## UTPB – Valet and Driveway Reno

**UTPB - VALET AND DRIVEWAY RENOVATION**  
6410 Fannin Street/ Houston, Texas 77030

**Date:** December 16, 2019  
**Johnston Project No.:** 19-00032-00  
**Prepared by:** Paula Gaviria

1. This Addendum addresses architectural, mechanical and electrical revisions as noted below, per comments from EH&S:

PROJECT NO: 19-00032-00  
DRAWN BY: JOHNSTON  
SHEET TITLE:  
**LIFE SAFETY PLAN**

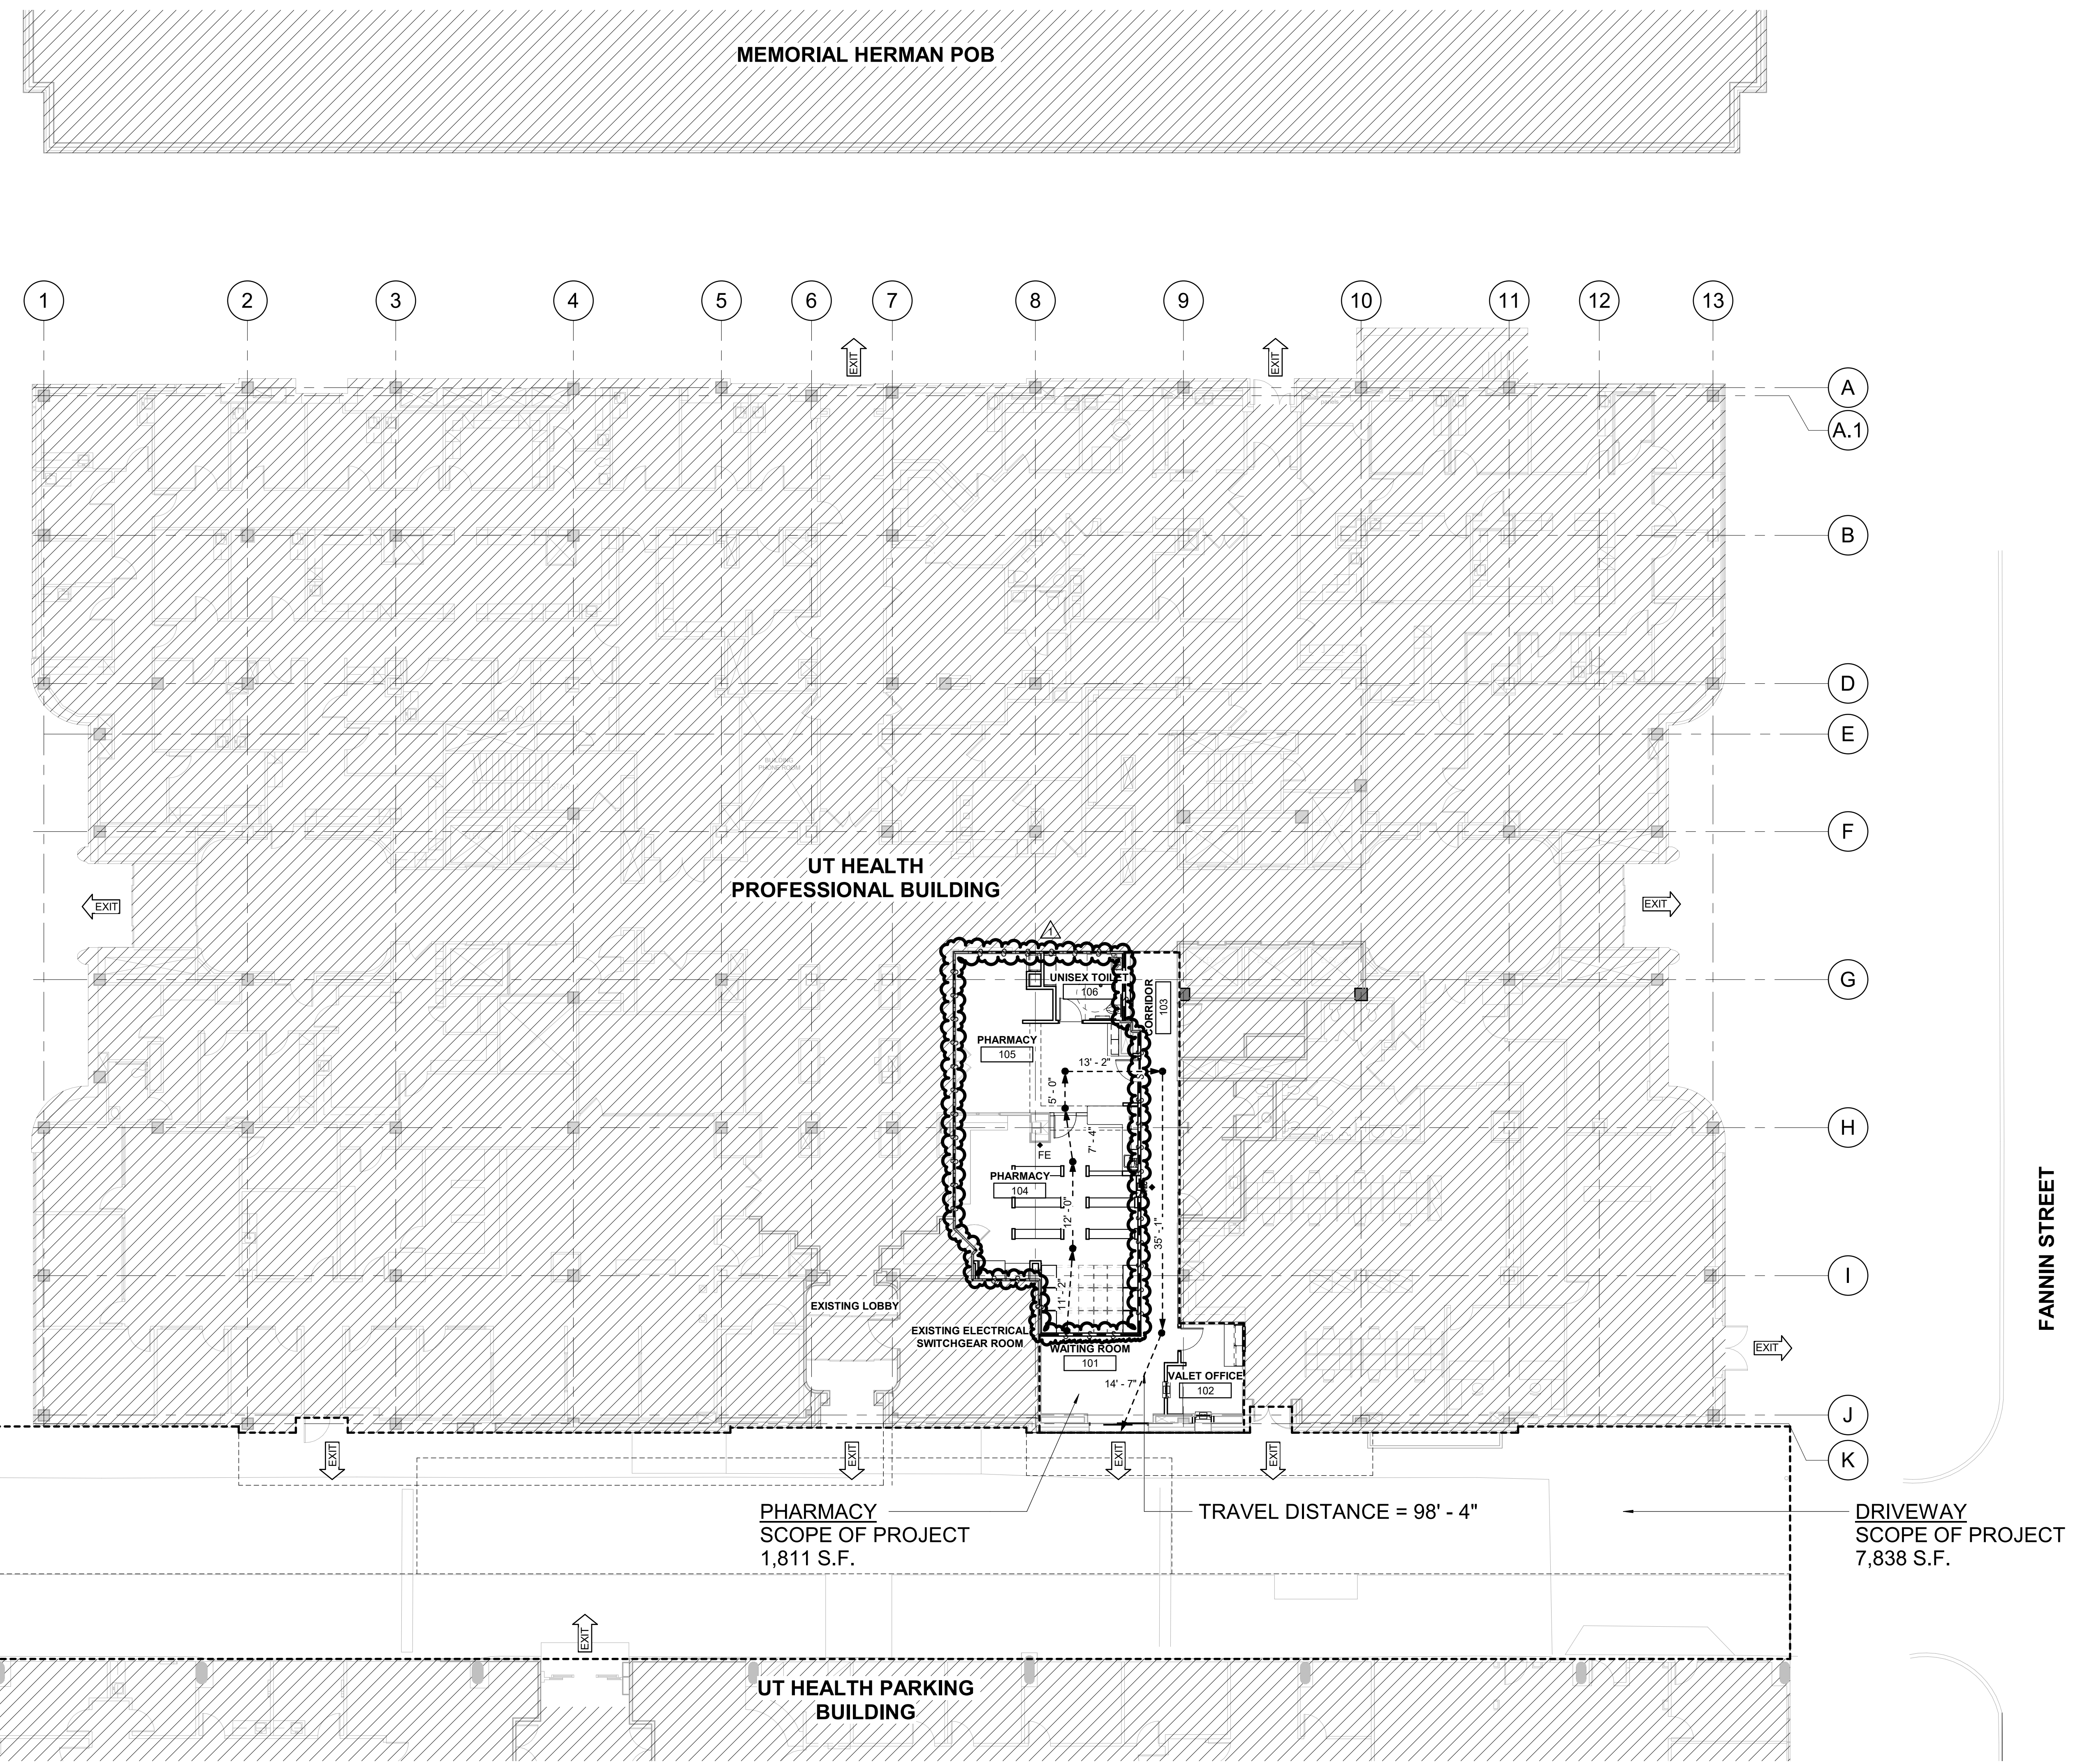
1. G0.00: COVER
  - Revised the name of the issue.
2. G0.01: DRAWING SHEET INDEX
  - Added Addendum #01 column and checked the sheets that are being issued.
3. G1.00: LIFE SAFETY PLAN
  - Revised existing and new fire tapes as smoke partitions.

SHEET TITLE:  
**OVERALL FLOOR PLAN**

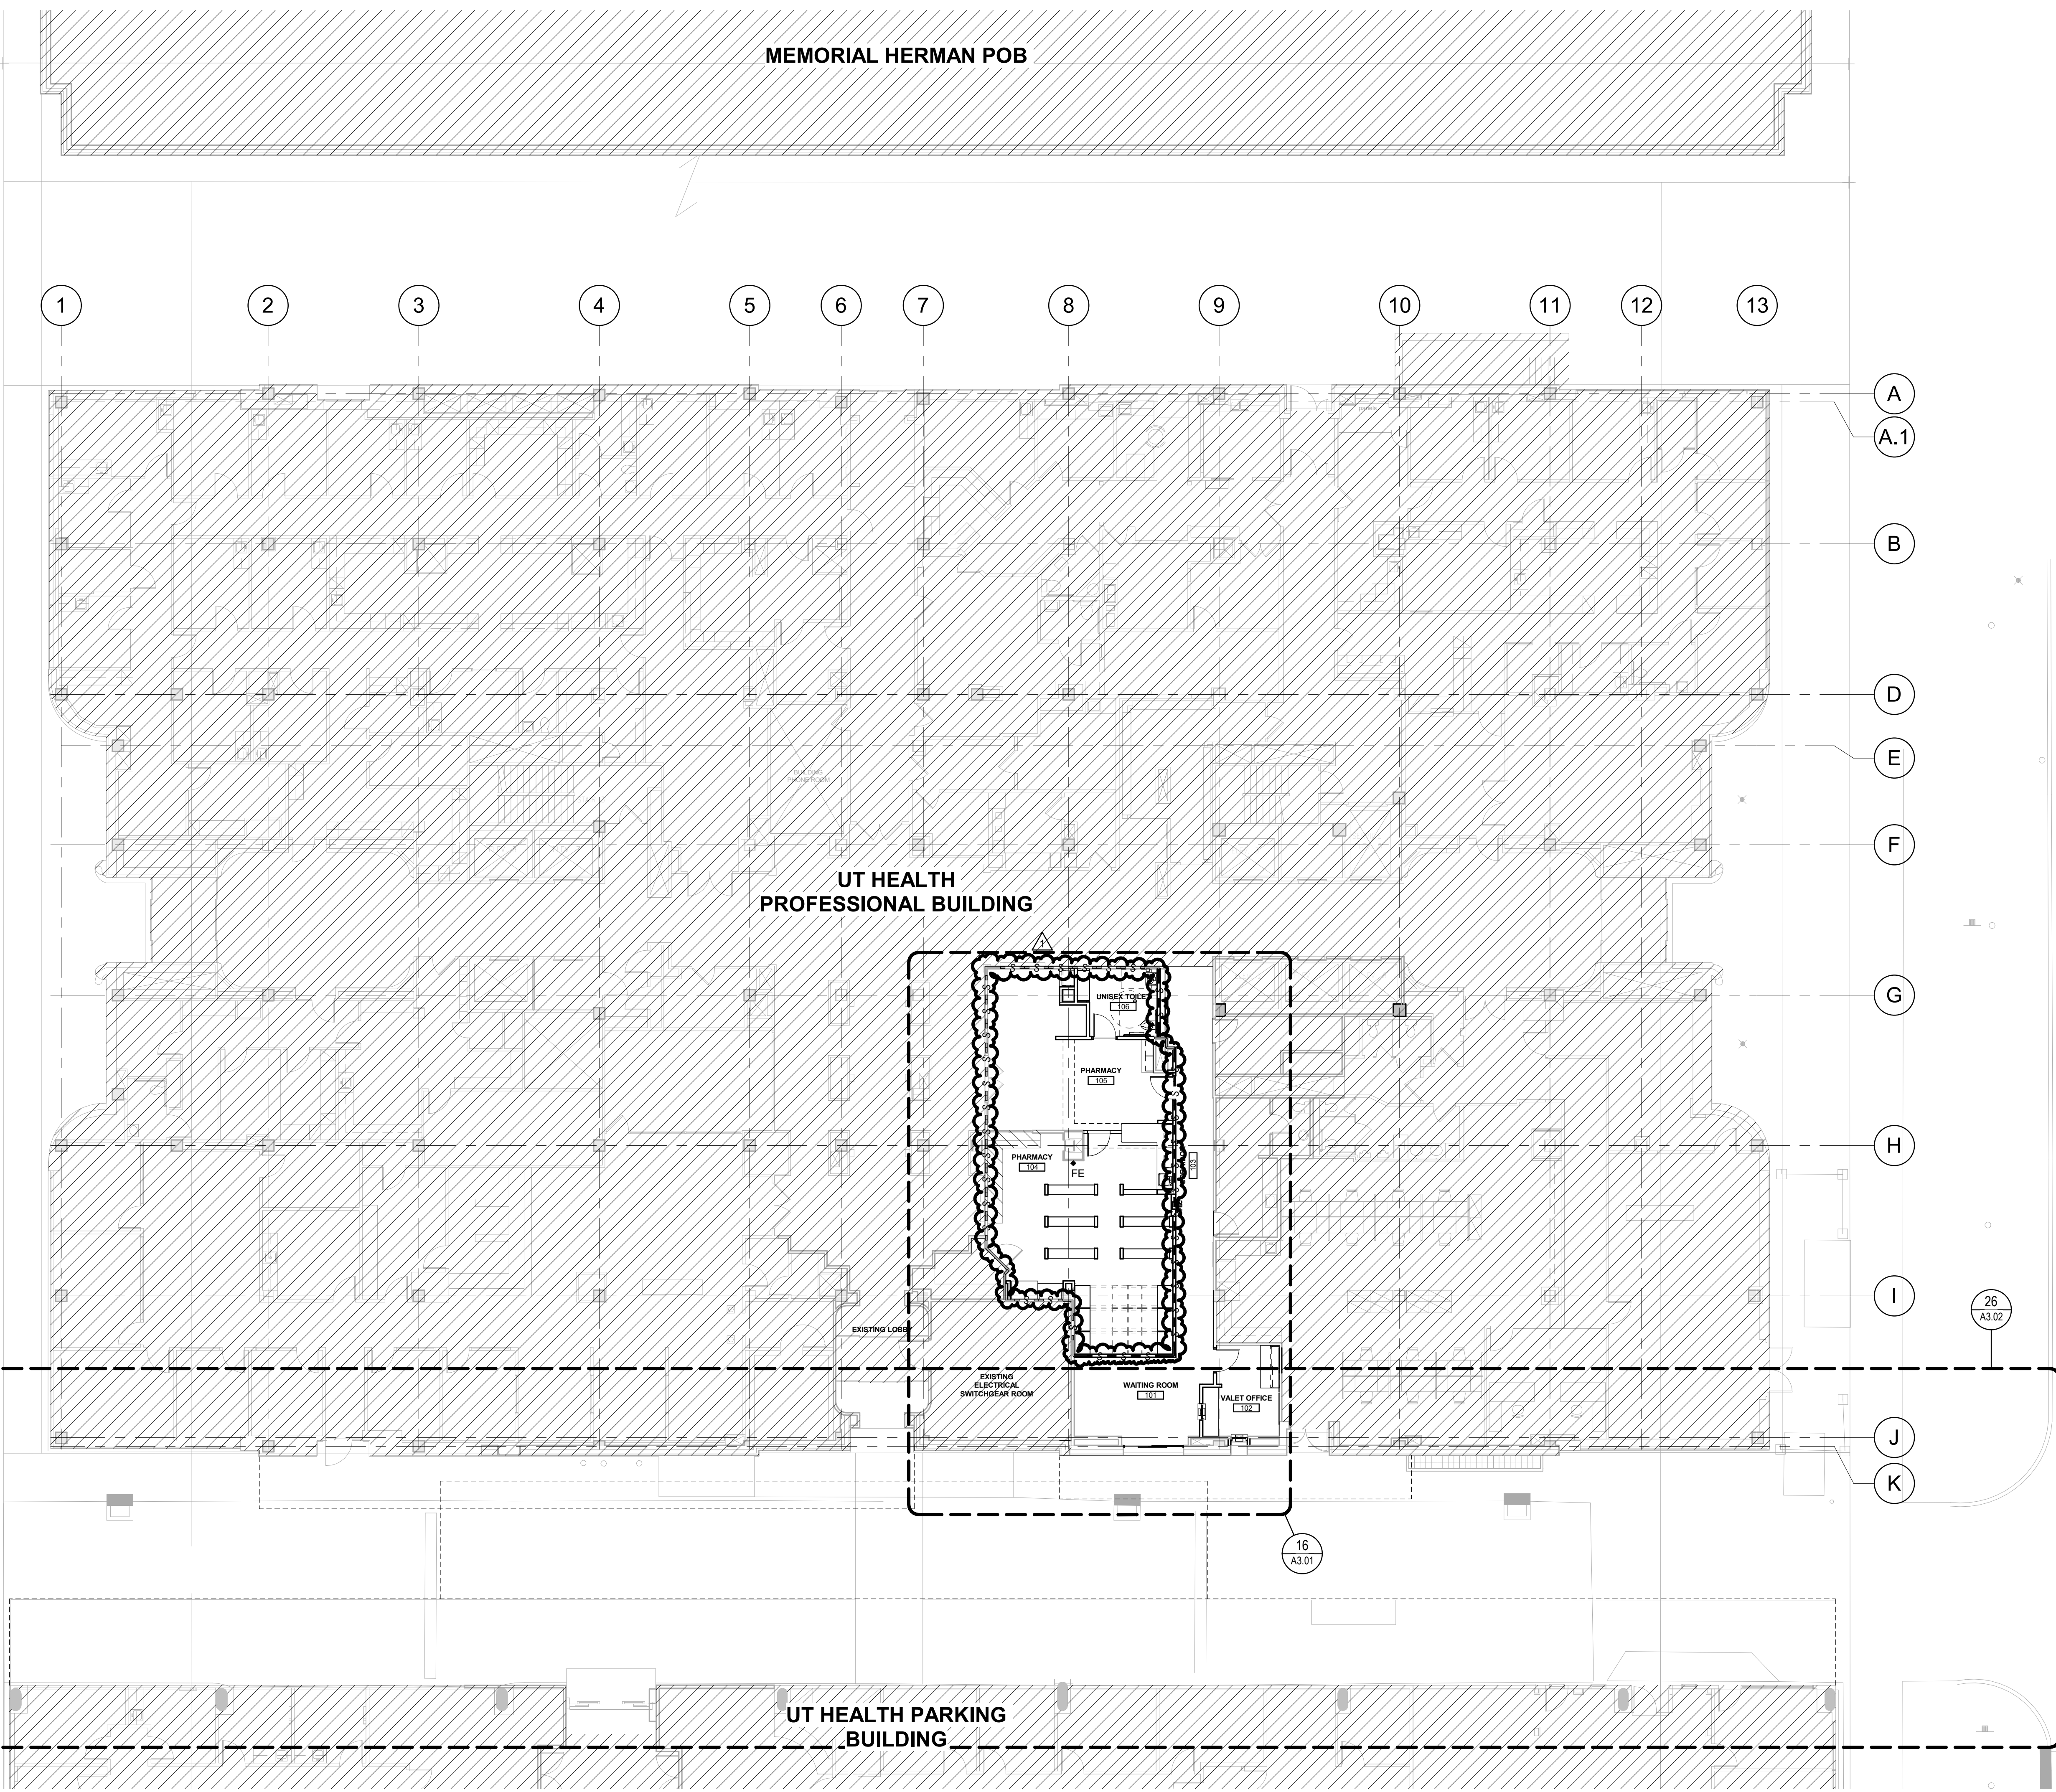
1. A1.01: OVERALL FLOOR PLAN
  - Revised existing and new fire tapes as smoke partitions.
2. A3.01: ENLARGED FLOOR PLAN & REFLECTED CEILING PLAN – INTERIOR
  - Revised existing and new fire tapes as smoke partitions.
  - Revised wall types to be smoke partitions.
  - Added exit sign to Corridor 103.
  - Added Fire Rated Legend to sheet.
  - Added a smoke detector in Pharmacy
  - Added and relocated fire strobes.
3. A10.04: PARTITION TYPES
  - Added wall type SA to sheet.
  - Removed wall type 1A from sheet.
4. A11.01: OPENING SCHEDULE
  - Revised door 105.1 and 106.1 fire rating.
